No. 1234
ATA Code 76-10

SUBJECT: ENGINE CONTROLS - INSTALLATION OF AN IMPROVED CARBURETOR HEAT CONTROL SPRING DETENT

EFFECTIVITY: BEECHCRAFT Duchess 76, serials ME-1 through ME-437;

Figure 1

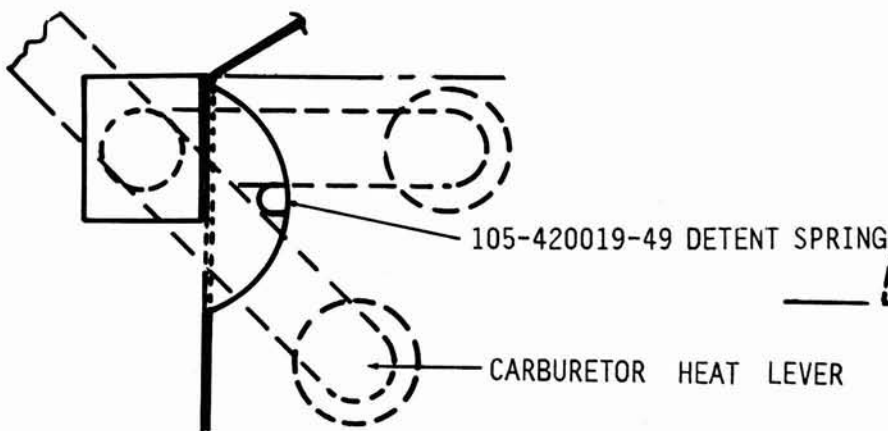
2. Position a P/N 105-420019-49 detent spring between the carburetor heat levers as shown in Figure 1. Ensure that the spring is positioned so that the edge of the lever passes the detent portion of the spring in both the ON and OFF positions.

Figure 2

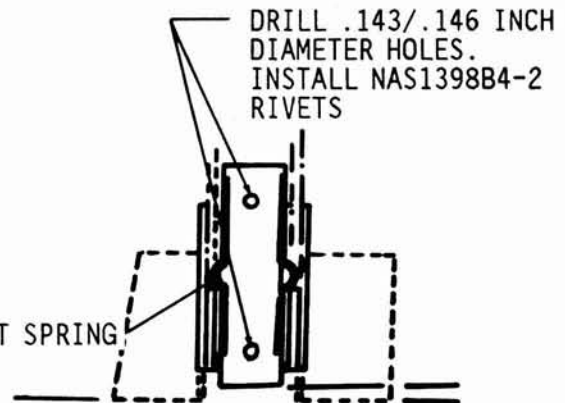
3. Drill two .143/.146 inch diameter holes in the escutcheon plate as shown in Figure 2.

Use a drill stop set to .250 inch depth when drilling the holes to prevent damage to components located on the opposite side of the escutcheon plate.
